United States Patent and Trademark Office

APPLICATION NO.	FILING D.	ATE	FIRST NAMED INVENTOR	ATTORNEY DOCKET NO.	CONFIRMATION NO.	
09/961,114	09/20/20	001	Donald V. Perino	RB1-035USC3	4507	
29150	7590 0	4/16/2003				
LEE & HAY				EXAMINER		
421 W. RIVE SPOKANE, V	RSIDE AVE, S VA 99201	STE 500	•	FIGUEROA, FELIX O		
				ART UNIT	PAPER NUMBER	
				2833		
				DATE MAILED: 04/16/2003

DETAILED ACTION

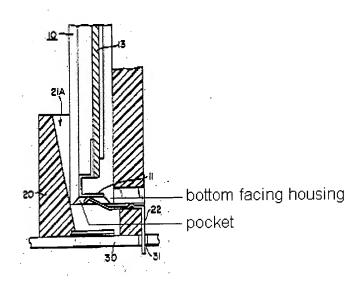
In response to applicant's argument that about Sonobe see figure below.

In response to applicant's argument that "Sonobe has not relationship to a pocket in a chip package as recited by Applicant's claim 87", please note that it has been held that a prior art reference must either be in the field of applicant's endeavor or, if not, then be reasonably pertinent to the particular problem with which the applicant was concerned, in order to be relied upon as a basis for rejection of the claimed invention.

See *In re Oetiker*, 977 F.2d 1443, 24 USPQ2d 1443 (Fed. Cir. 1992). In this case, Sonobe teaches the use of a package having a bottom-facing housing having a pocket to protect the lead from external tampering.

Additionally, it is noted that claim 88 only requires that in case of compression of the lead, the same be disposed within the pocket. Clearly, Sonobe teaches this recitation.
